**Re: Minor Project Refinement No. 15 for the South Orange County Reliability Enhancement Project.**

## South Orange County Reliability Enhancement Project CPUC Minor Project Refinement Form

**Report No.:** 15

**ATTACHMENT B**  
**MPR-15 Figure**

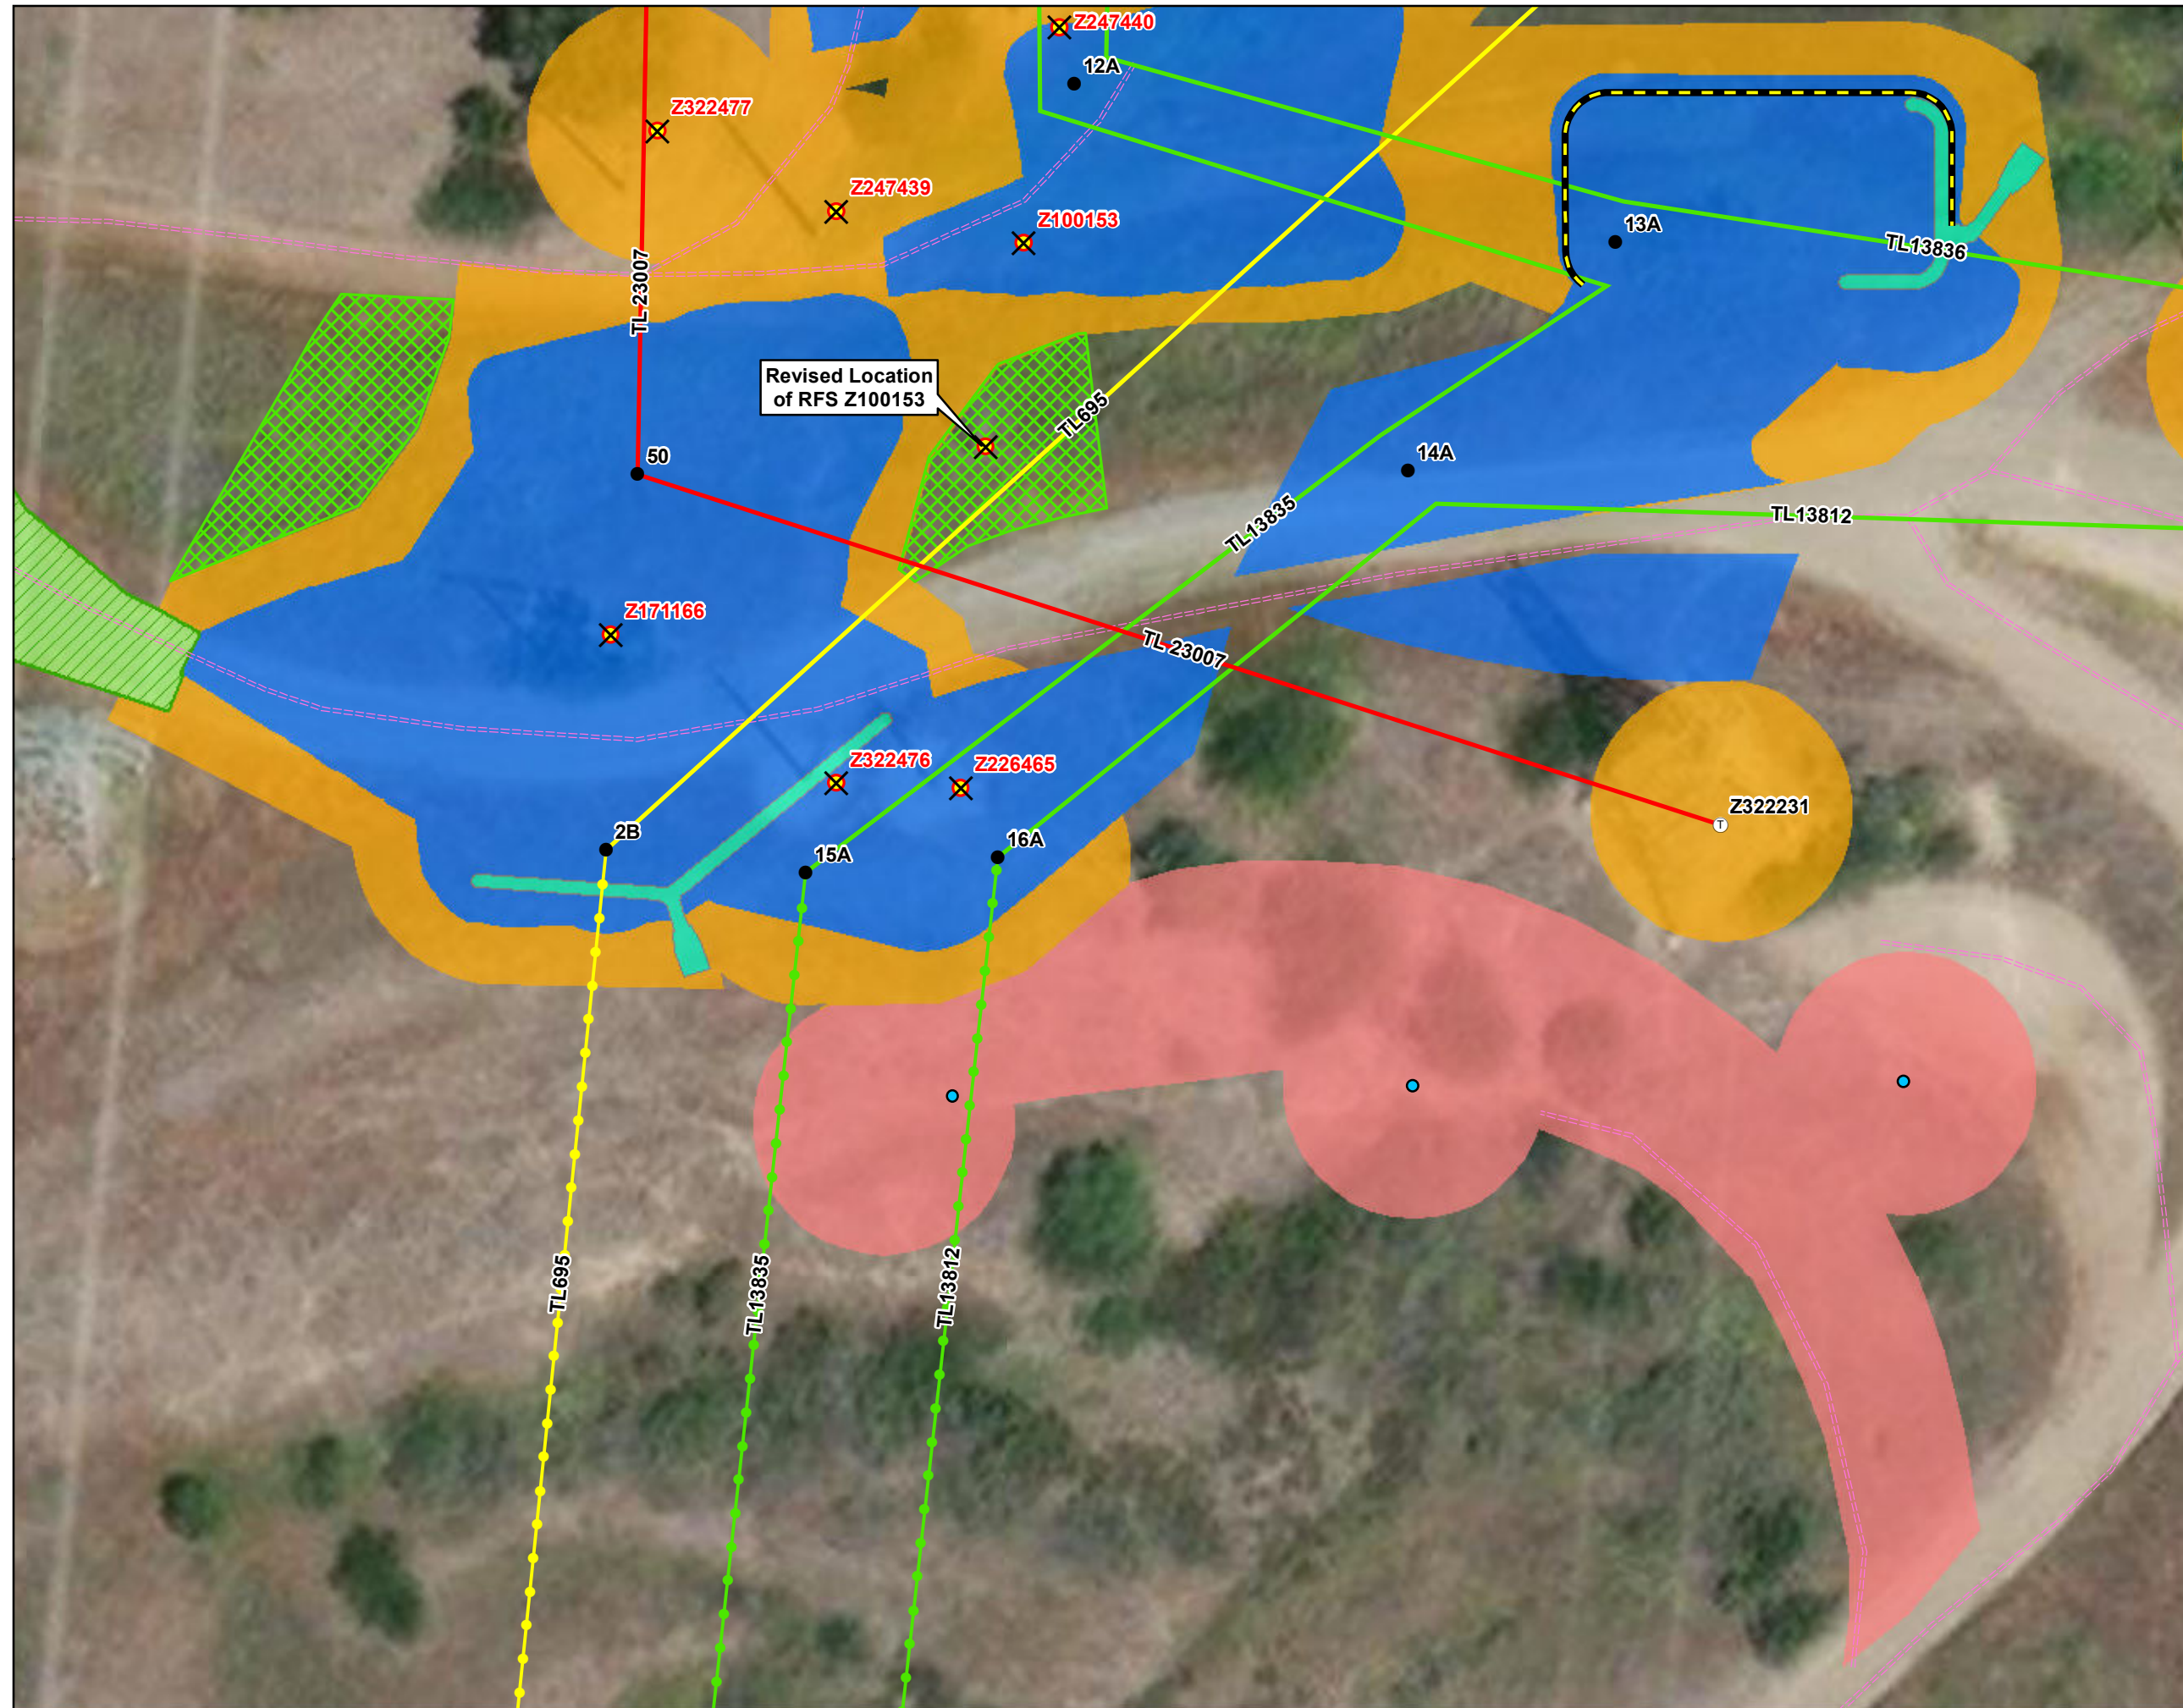
The eastern MPR-15 temporary work area is required in order to access the remove-from-service (RFS) pole Z100153. Existing RFS pole Z100153 was moved approximately 50 feet south in a non-Project related action and now falls outside of the approved Project work areas (See **Attachment B, MPR-15 Figure**). The pole will be accessed from the east via the existing access road. The pole will be dismantled by crane and hauled away by a flatbed truck as described in Section 2.4.5.4 of the FEIR. The concrete foundation will be jackhammered and removed with an excavator. There is no ground disturbance anticipated to be required within the MPR-15 work areas with the exception of the Z100153 pole removal activities.

The construction contractor identified the need to utilize the eastern MPR-15 work area in order to access the RFS pole Z100153. RFS pole Z100153 is currently located approximately 50 feet south of its original mapped location within the 12A work area due to non-Project related action. It now falls outside of the approved Project work areas (See **Attachment B, MPR-15 Figure**). The pole will be accessed from the east via the existing access road. The pole cannot be accessed from the west (existing Location 50 work area) due to the slope and existing transmission structure down guy wires. As stated above, the western MPR-15 work area is not anticipated to be utilized by the Project, but is being included as part of the corrective action for the compliance incident on November 29, where the area was mowed.

Although the proposed MPR-15 temporary work areas total 2,925 square feet (0.07 acre), a large portion of the work area contiguous to the Location 50, 2B, 15A, and 16A work area is no longer being utilized by the Project (see **Attachment B, MPR-15 Figure**). This southern portion of work area is 14,300 square feet (0.32 acre), therefore the overall temporary disturbance acreage would not be increased by the addition of the MPR-15 work areas.

**Photograph 1:**  
View of the western MPR-15 work area. This area is not anticipated for Project use but is being included as part of the corrective action for the compliance incident from November 29, 2022 where this area was mowed outside of work limits.  
Facing: South

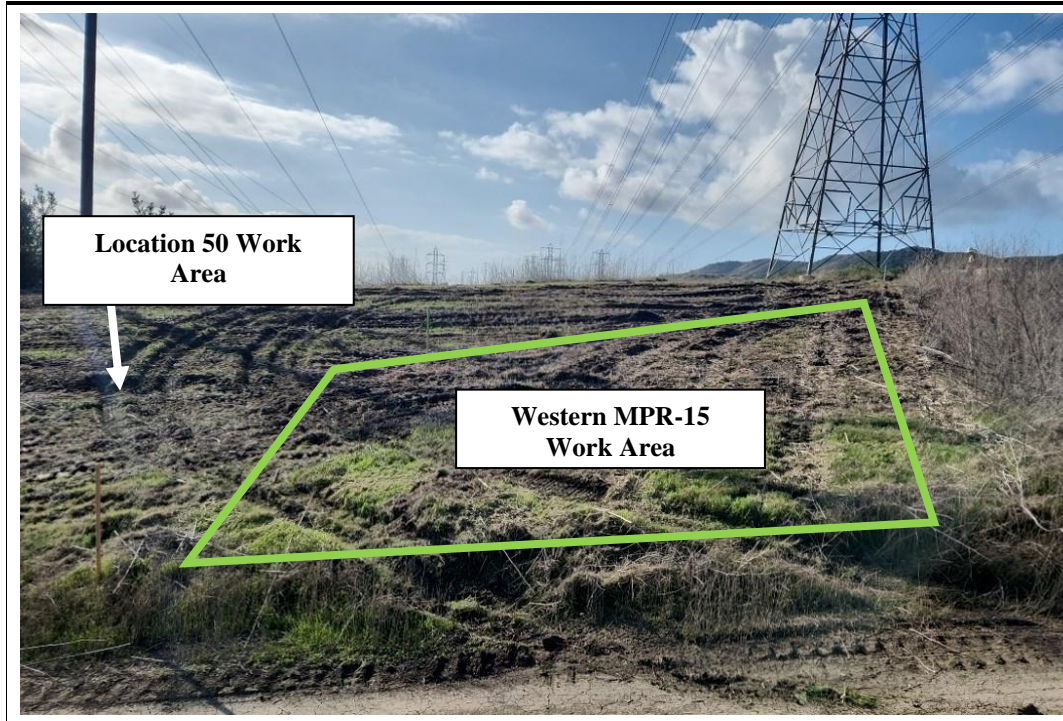
The western MPR-15 temporary work area is being included as part of the corrective action for the compliance incident that took place on November 29, 2022. The area was mowed outside of the approved work limits during vegetation trimming activities at Location 50. The Project does not currently anticipate the use of this western area, but the additional temporary impact is being recorded in MPR-15 for the Project record.
